# Access Compliance Report

### (Curb Ramps)

Intersection ID: 42741	Main Street: DANIEL_PLACE_DR	Cross Street: MACANTHRA_DR	Location: NW
ADA ID: 2730EA87A0D6	Ramp Type: PerpDiag	Initial Pass/Fail: Fail	Overall Compliance: No
Severity Score: 46.25			
Codes/Mitigation Info/Possible Solution		Field Measurements/Component Compliance

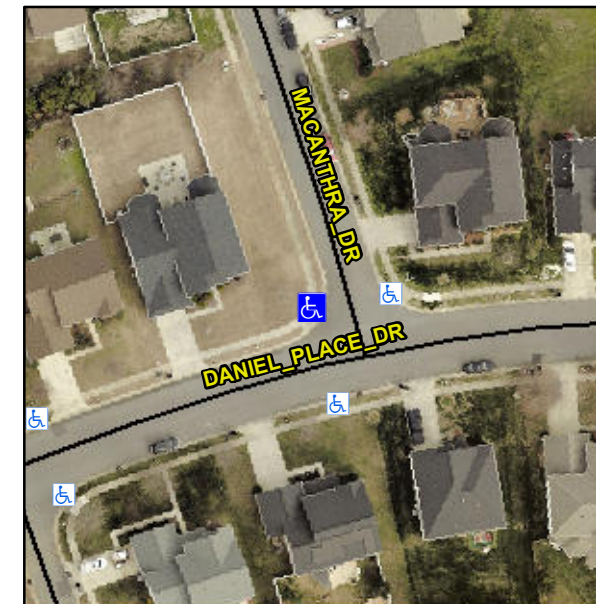
**Not Found, R304.5.1, R304.2.2, R304.5.3**

Compliance	Description	Data	Compliance	Description	Data
N/A	Ramp Length (in)	50.5	No	Ramp Slope (%)	9.7
No	Ramp Width (in)	41.0	No	Ramp XSlope (%)	9.3
N/A	Flare Type LT	N/A	N/A	Flare Type RT	N/A
N/A	Flare Slope LT (%)	N/A	N/A	Flare Slope RT (%)	N/A
N/A	Flare Traversable LT?	N/A	N/A	Flare Traversable RT?	N/A
N/A	Landing Length (in)	N/A	N/A	DWS Provided?	N/A
N/A	Landing Width (in)	N/A	N/A	DWS Contrast?	N/A
N/A	Landing Slope (%)	N/A	N/A	DWS Length (in)	N/A
N/A	Landing X Slope (%)	N/A	N/A	DWS Full Width?	N/A
N/A	Landing Curb? (Y/N)	N/A	N/A	DWS Offset (in)	N/A
N/A	Shared Landing?	N/A			
N/A	Gutter Ponding?	N/A	N/A	Gutter Slope (%)	N/A
N/A	Gutter Lip Ht (in)	N/A	N/A	Gutter X Slope (%)	N/A
N/A	Painted X Walk1?	No	N/A	Painted X Walk2?	No
	X Walk 1 Direction	To S		X Walk 2 Direction	To E
N/A	X Walk 1 Width (in)	N/A	N/A	X Walk 2 Width (in)	N/A
	X Walk 1 Slope (%)	3.0		X Walk 2 Slope (%)	8.6
	X Walk 1 X Slope (%)	6.4		X Walk 2 X Slope (%)	8.2

**Remove & Replace Curb Ramp With Two New Directional Ramps or Equivalent.**
